DATE	REV	DESCRIPTION
12/12/2019	A	DA ISSUE
25/05/2020	B	DA ISSUE - EX. GROUND LEVEL INFORMATION ENHANCED AS REQUIRED BY COUNCIL

PROJECT
41 & 43 BEACH ROAD COLLAROY
LO1 1 DP300846 AND LOT 2 SEC 7 DP7391

DRAWING NO.
DA 100

DRAWING TITLE					
			EX. AND PROPOSED RL ANALYSIS AGAINST DCP AND LEP REGULATIONS			1:100 at A1 & 1:200 at A3	DA 105

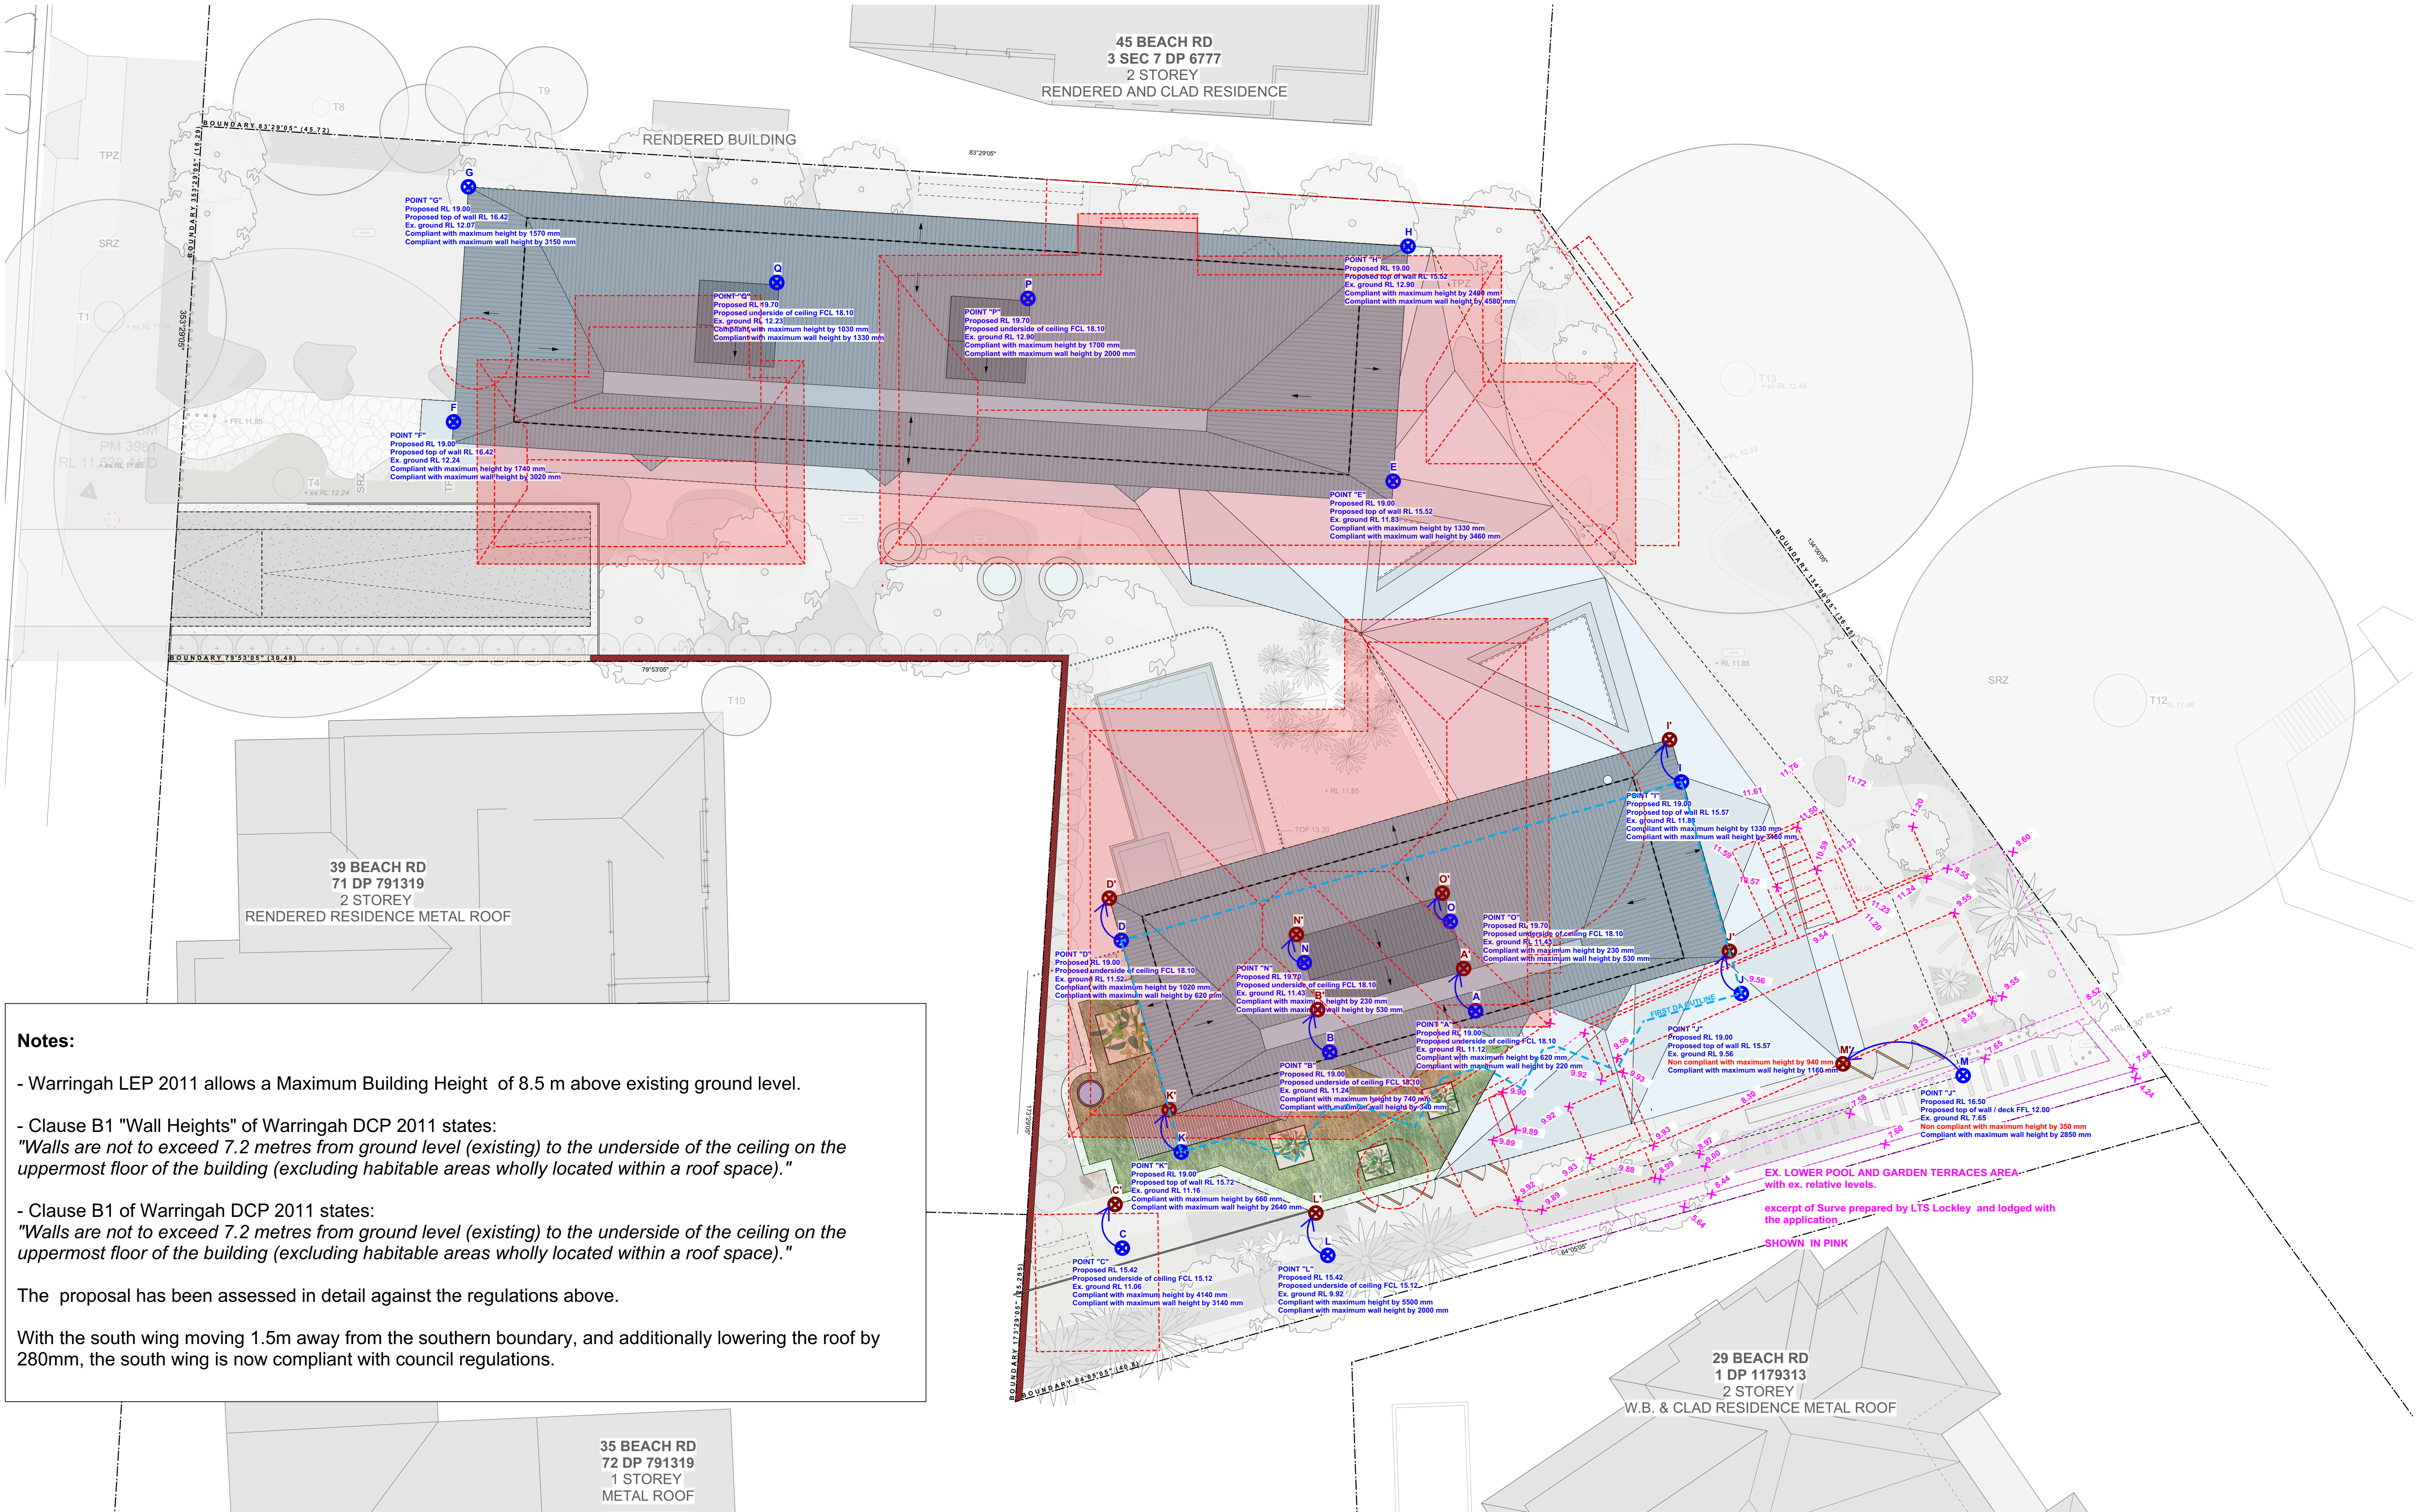
- Warringah LEP 2011 allows a Maximum Building Height of 8.5 m above existing ground level.
- Clause B1 "Wall Heights" of Warringah DCP 2011 states:
"Walls are not to exceed 7.2 metres from ground level (existing) to the underside of the ceiling on the uppermost floor of the building (excluding habitable areas wholly located within a roof space)."
- Clause B1 of Warringah DCP 2011 states:
"Walls are not to exceed 7.2 metres from ground level (existing) to the underside of the ceiling on the uppermost floor of the building (excluding habitable areas wholly located within a roof space)."

The proposal has been assessed in detail against the regulations above.

With the south wing moving 1.5m away from the southern boundary, and additionally lowering the roof by 280mm, the south wing is now compliant with council regulations.
